Our reference: ECM Ref: 9748526  
Contact: Kathryn Saunders  
Telephone: (02) 4732 8567

**Response to Environmental Impact Statement: SSD-10272349, Proposed Yiribana Logistics Estate at 754-770 and 784-786 Mamre Road, Kemps Creek, Lot 60 in DP 259135 & Lot 59 in DP 259135**

**Image 1:** Proposed works. Source: Applicant’s EIS.

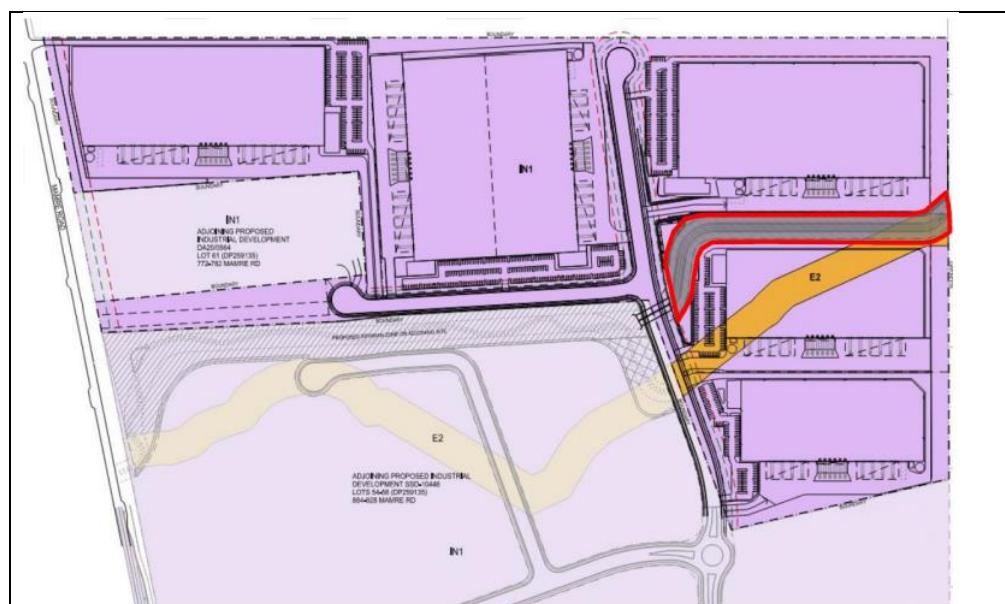
The proposal includes site clearing, extensive cut and fill works and civil works to remove an identified riparian corridor and to construct a warehouse and ancillary structures over this land which is located within an E2 Environment Conservation zone under SEPP WSEA.

The proposed works are not permissible within the E2 zoning and are in stark opposition to objectives of the E2 Environment Conservation zone.

Adjacent proposals also replicate the removal of the identified riparian lands (to the south and east) within the E2 Environmental Conservation zone.

**Image 2:** Excerpt from ‘CT Environmental Ecosystem Management and Monitoring – Mamre Road Precinct Rezoning: Waterway Assessment, dated April 2020’, indicating Unnamed Tributary South Creek 1.

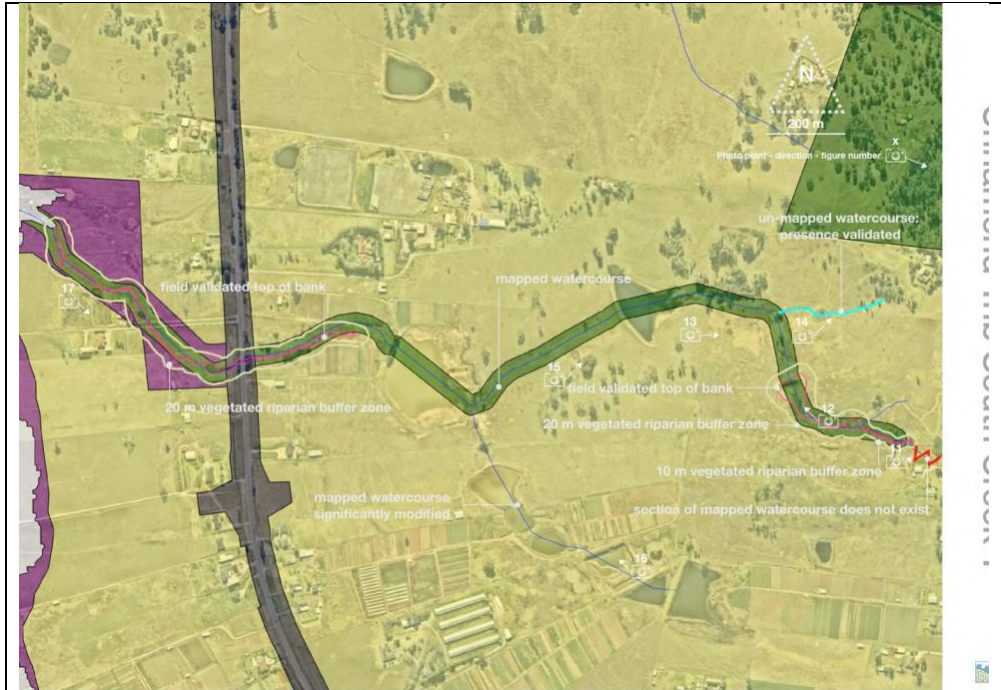
The report provides a thorough and ground truthed assessment of tributaries within the precinct, including 'Unnamed Trib South Creek 1' which is positioned central to the E2 zone on the subject lands (refer **Image 2**).

How the applicant’s consultant has arrived at an opposing conclusion is to be examined and an independent peer review may be necessary.

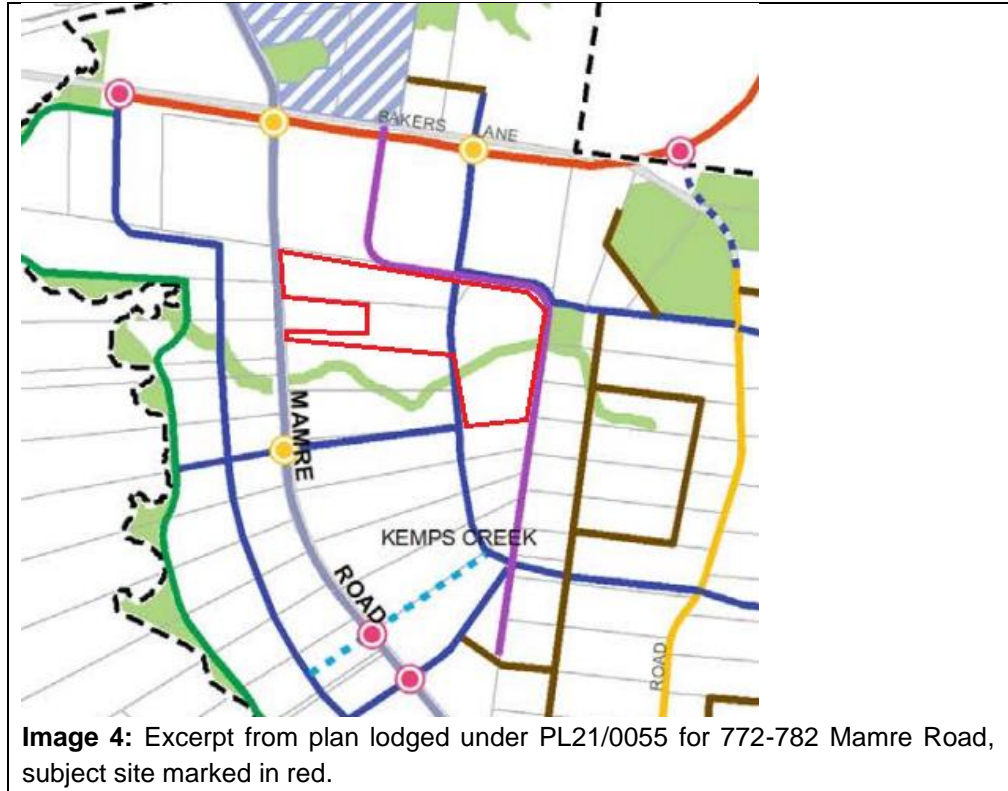
Plans indicate that the intent is to provide a permanent connection to the west and a future intersection with Mamre Road, along the northern boundary of Lot 59 DP 259135, and that the cul-de-sac will be temporary.

Further to the above, the SSD and withdrawn DA plans referenced above, indicate that the cul-de-sac to the southeast is intended to provide direct access to the future redevelopment at 772-782 Mamre Road.

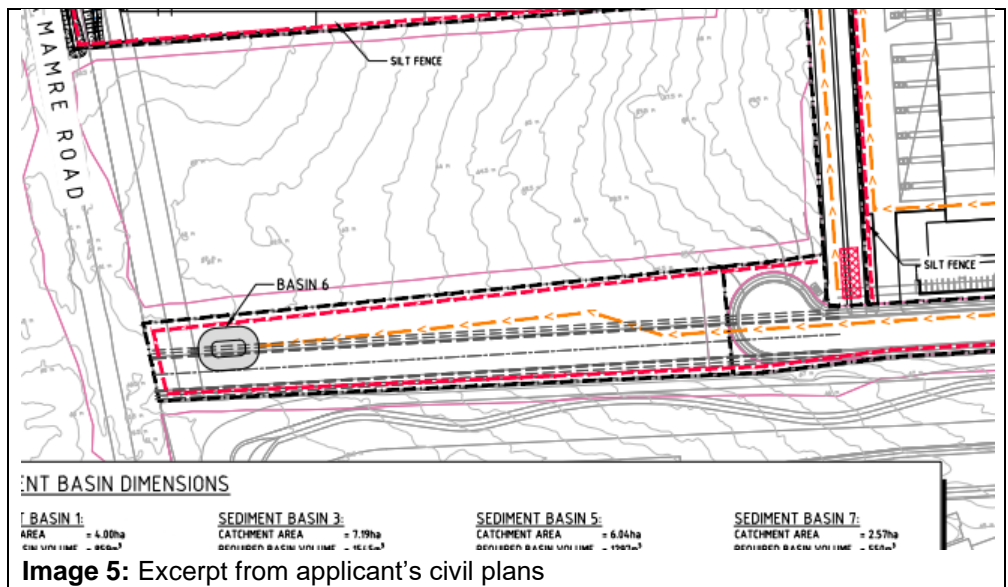
In addition to the above, this proposed southern east-west road does not align with the Road Network Map at Figure 14 of the DCP (refer **Image 4**).

Limited detail is provided in the SSD application which demonstrates that an intersection with Mamre Road could be facilitated in the location required (refer **Image 5**), and that sufficient area for the construction of a future intersection (signalled as may be required) could be accommodated on the subject site, and which would avoid reliance on land not in the proponent’s ownership. Basin 6 would require relocation.
